1133-1145 GRISWOLD
 1133-1145 GRISWOLD STREET
 DETROIT, MI 48226

DTE COMMENTS	Date
BID	06-02-23
PERMIT	05-01-23
100% DD	03-31-23
HDC SUBMISSION	02-13-23
SCHEMATIC DESIGN	12-21-22
SITE PLAN APPROVAL	03-24-22
Revision	Date

Sheet Title
EXTERIOR ELEVATION

A202

1 SOUTH ELEVATION - ALLEY
 SCALE: 1/8" = 1'-0"
 REFERENCE LOCATIONS:

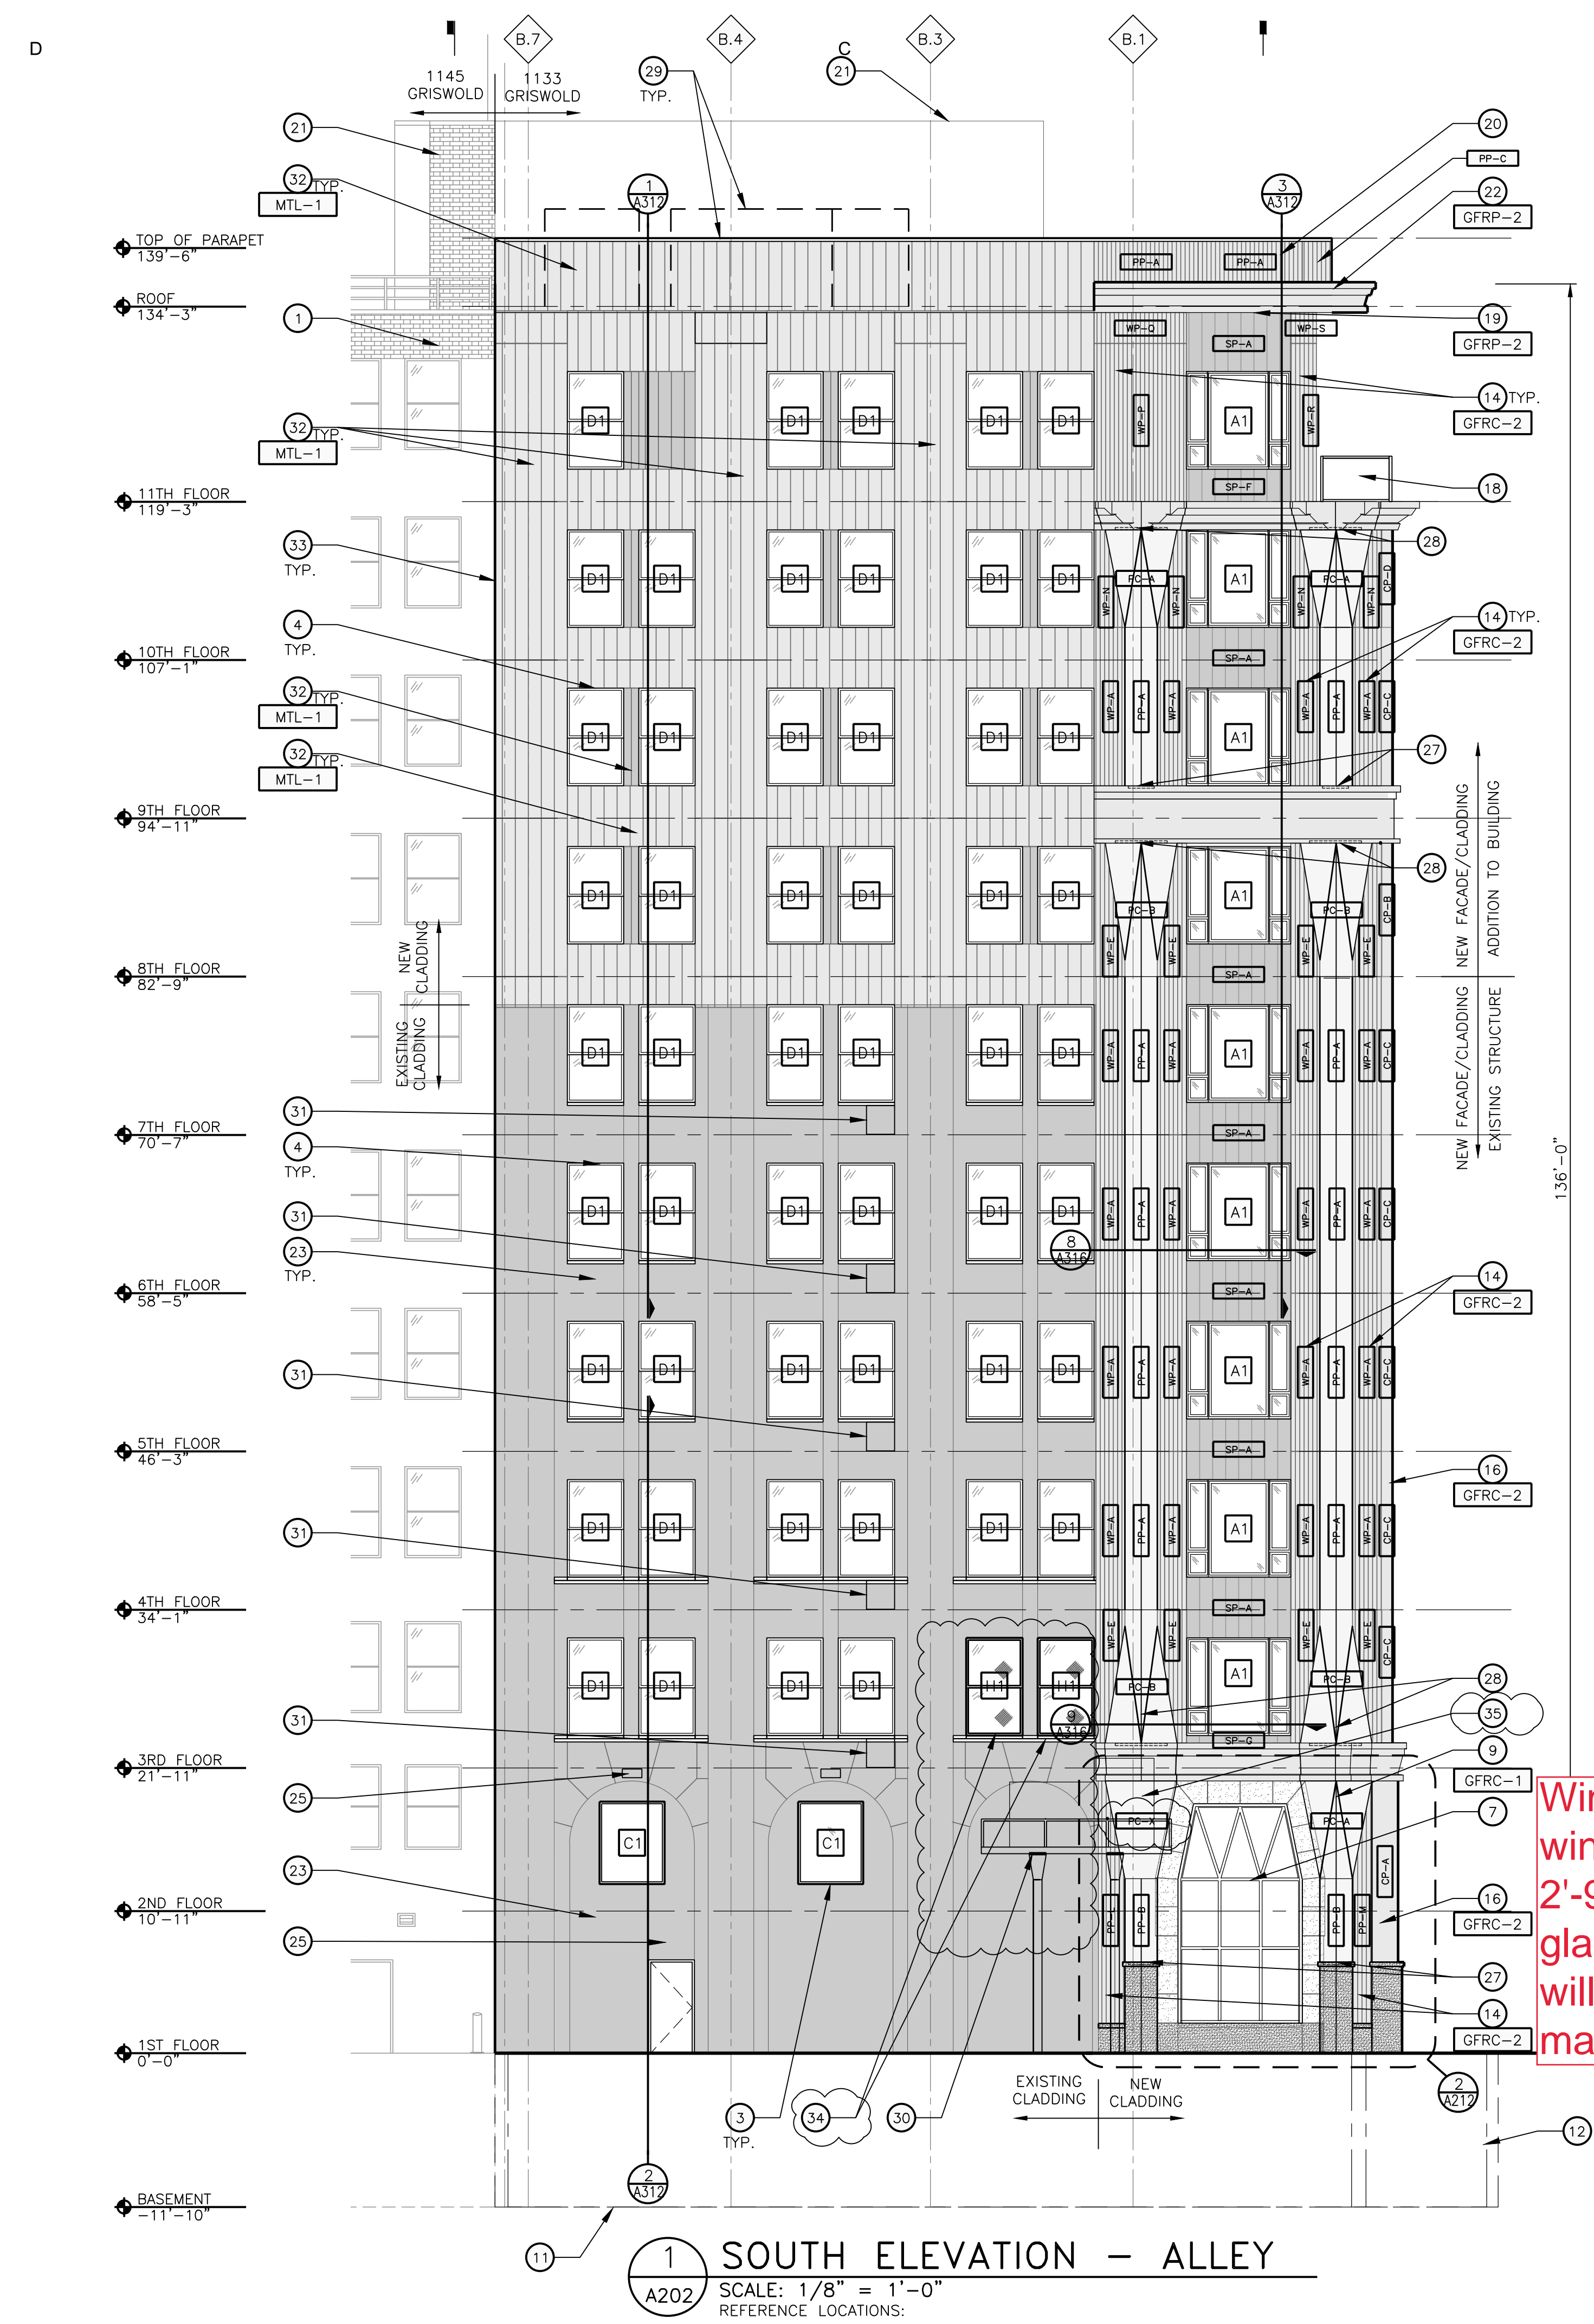
Window behind transformer to be infilled. There will be no windows within 2' of the platform or transformers. Glass that is 2'-9" from the top of transformer will have steel sash and wire glass construction. Windows 2'-9" will not operate. No window will exist behind the DTE transformers. No 'bump out' of facade materials will exist behind DTE transformer.
